AQUIND INTERCONNECTOR

Applicant's Responses to Deadline 6 Submissions – Hearings – Appendices

Document Ref: 7.9.33.1

PINS Ref.: EN020022

Figure 6: Proposed construction traffic management on Anmore Road

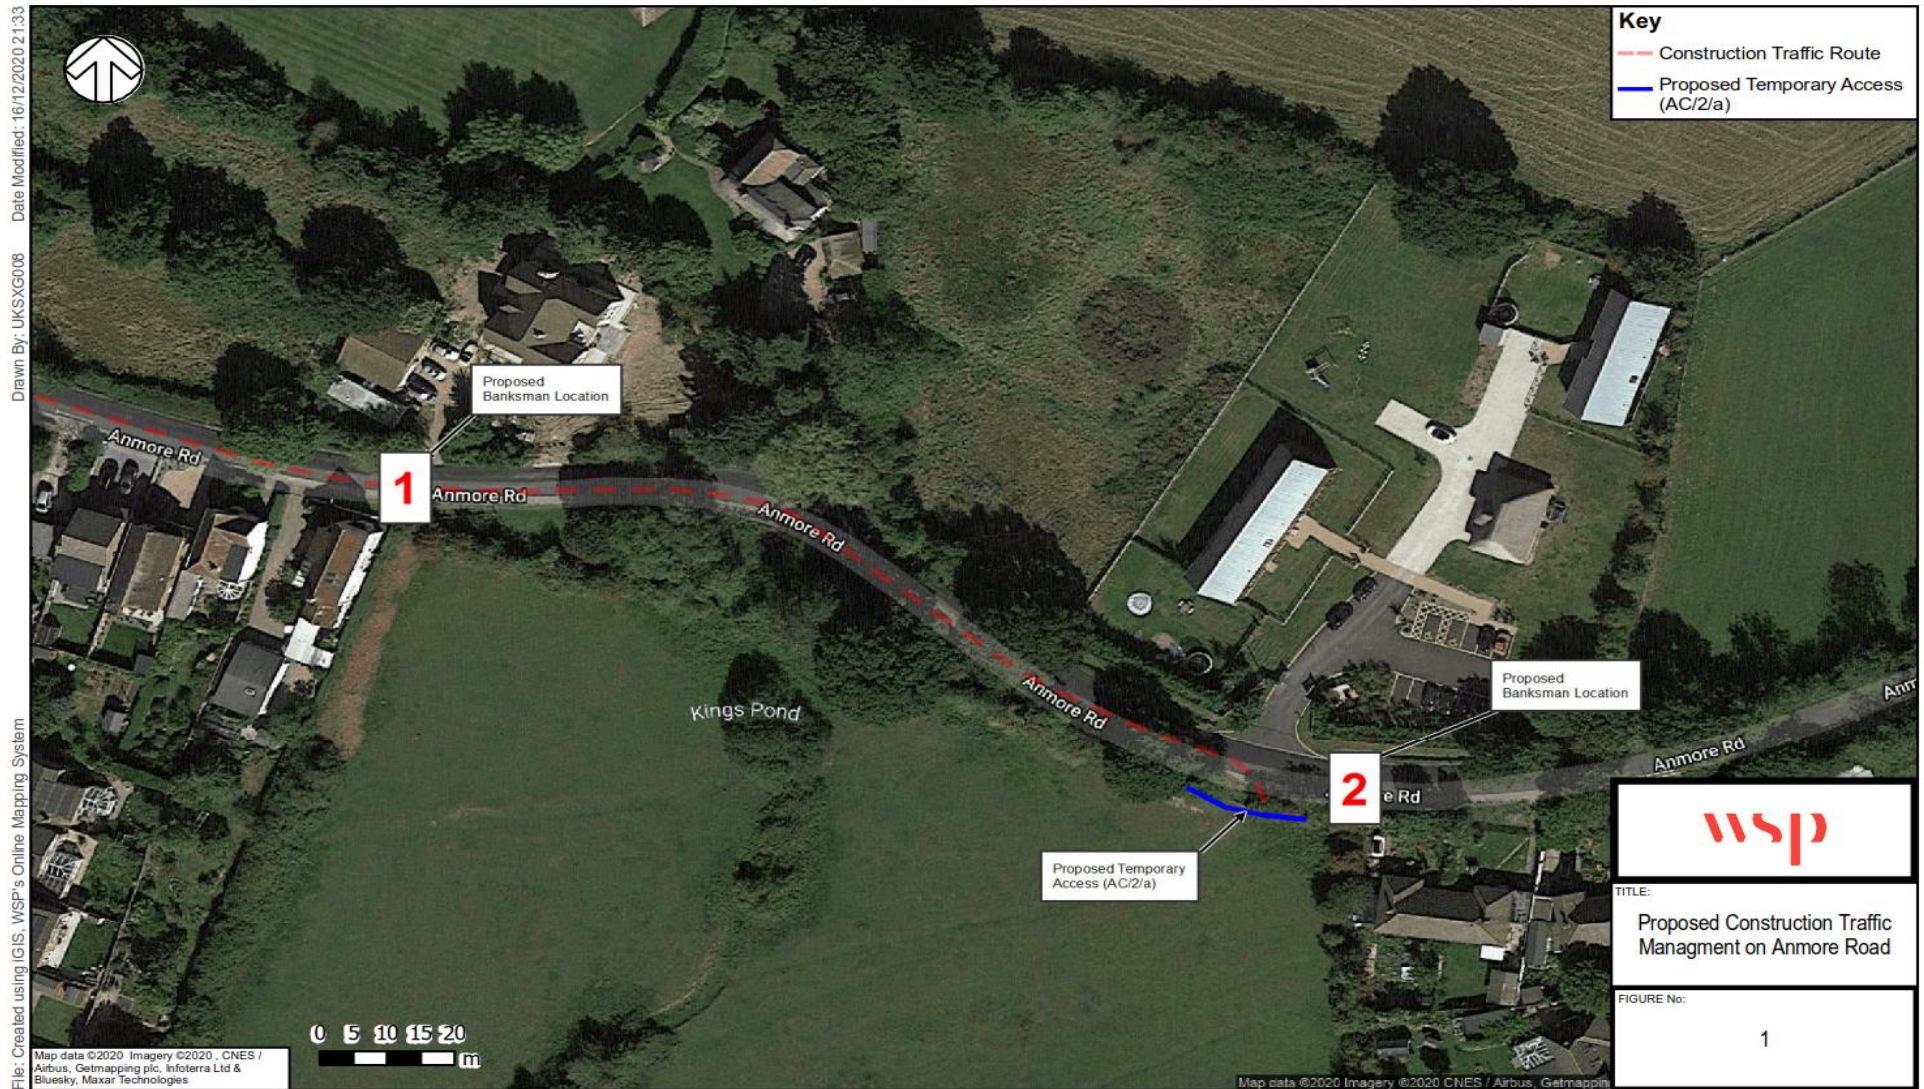
1. Outside of 126 Anmore Road, prior to the bend in Anmore Road; and
2. To the immediate east of the proposed access junction (AC/2/a).

The proposed siting on banksmen is also set out in Figure 6 below.

It is proposed that the traffic marshal at location (1) will stop eastbound traffic whilst HGV's are exiting the access point on Anmore Road (AC/2/a), and that traffic marshal location (2) will stop westbound traffic when HGV's are approaching the access (AC/2/a).
